MODIFICATION INSTRUCTIONS

KODAK MULTILOADER 700

Modification No. 13

Purpose:

figure 1

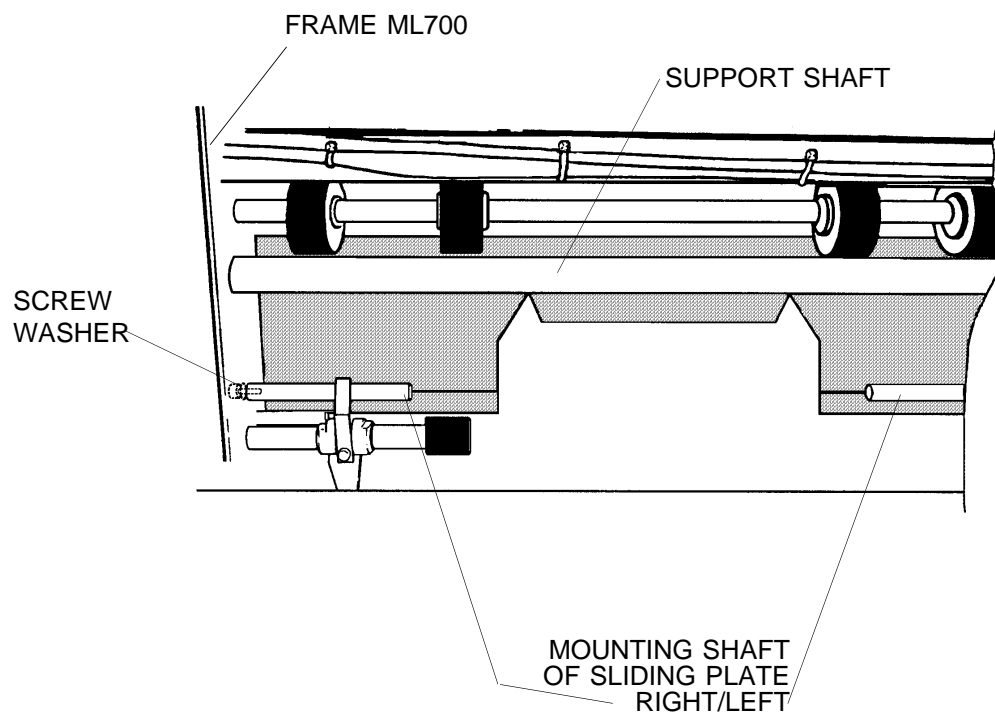
- 1.** Open right COVER.
- 2.** Disconnect ML 700 from TUNNEL.
- 3.** Remove REAR COVER.
- 4.** Remove SCREW with WASHER. See figure 1.

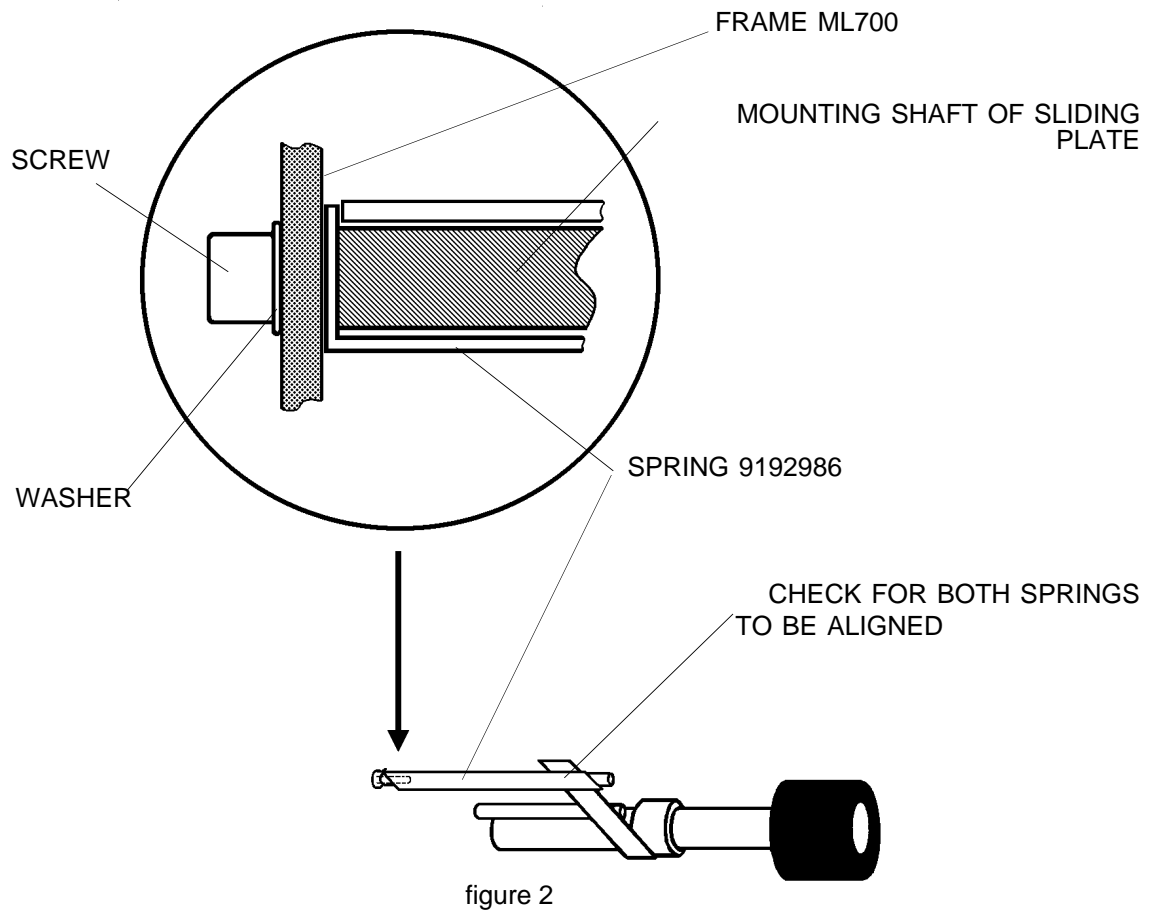
- 5.** Install SPRING 9192986 with SCREW and WASHER between FRAME of ML700 and MOUNTING SHAFT of SLIDING PLATE. See figure 2.

Do not bend the SPRINGS. Check that the SLIDING PLATE rests tightly on the SUPPORT SHAFT after tightening the SCREW.

figure 3

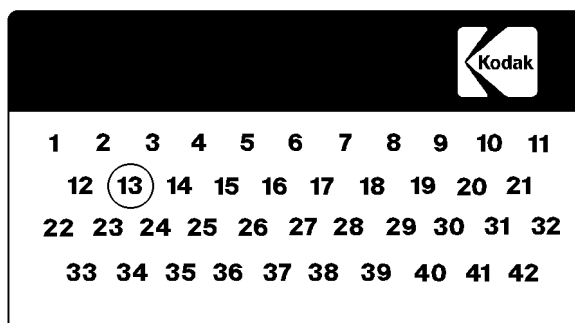
7. Circle No. 13 on Mod Label.
